# SERVICE BULLETIN

M1438 2017-01-25

# M1438: NEUTRAL SWITCH INVENTORY REMOVAL

Figure 1. Neutral Switch

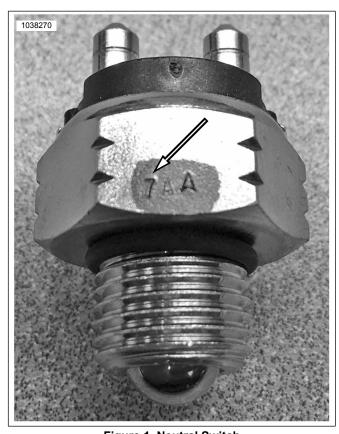
- 2. See Figure 1. Inspect the assembly code.
  - Switches with the 3-digit assembly code that begin with the number "6" or lower should be removed from inventory.
  - b. Switches with the 3-digit assembly code that begin with a "7" or greater can remain in inventory and be used for repair.
- 3. File a warranty claim for switches that failed the inspection. Use the appropriate table in Credit Procedure.
- Order replacement switches (Part No. 33926-06B) using the standard part ordering process for your market. Suspect inventory has been removed from HDMC warehouses.
